Addendum – Recommendations for Liquefied Gas Carrier Manifolds, Second Edition (2018)

While reading the publication, please note the following addendum.

Figure Ad1: Minimum depth of manifold drip tray

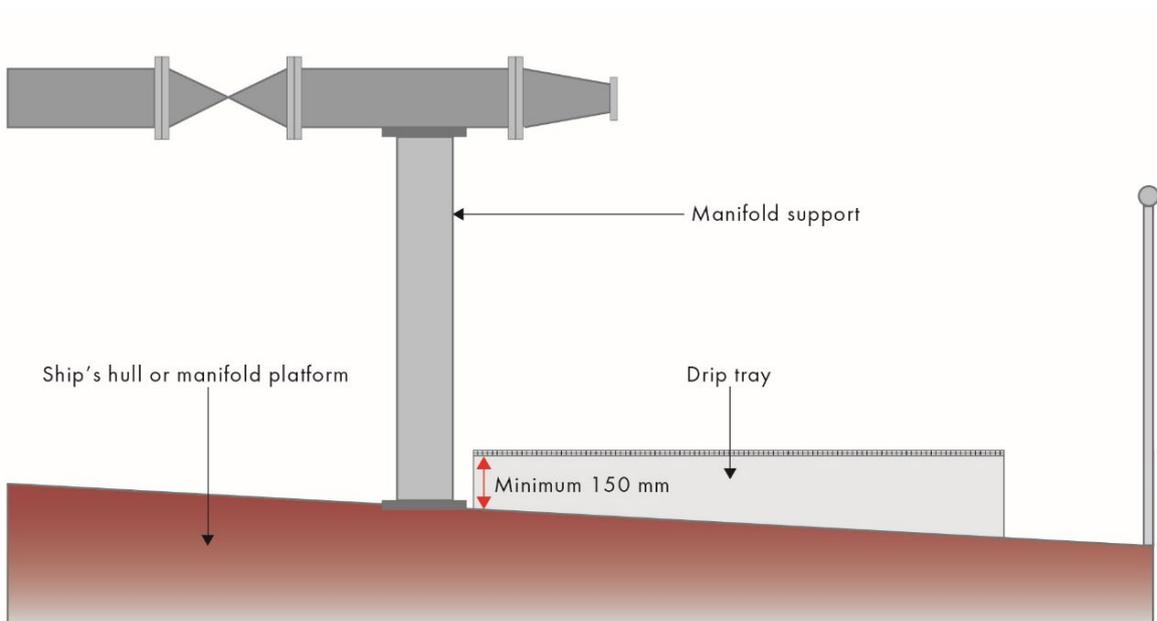
p.20, 3.3 Drip Trays

Original sentence:

“A drip tray should have a minimum depth of 300 mm.”

After the original sentence, please add:

‘To accommodate different design options, the minimum depth of a drip tray may be 150 mm along the inner edge as shown in Figure Ad1 below. The total volume of the drip tray should be equivalent to the volume calculated using a minimum depth of 300 mm.’
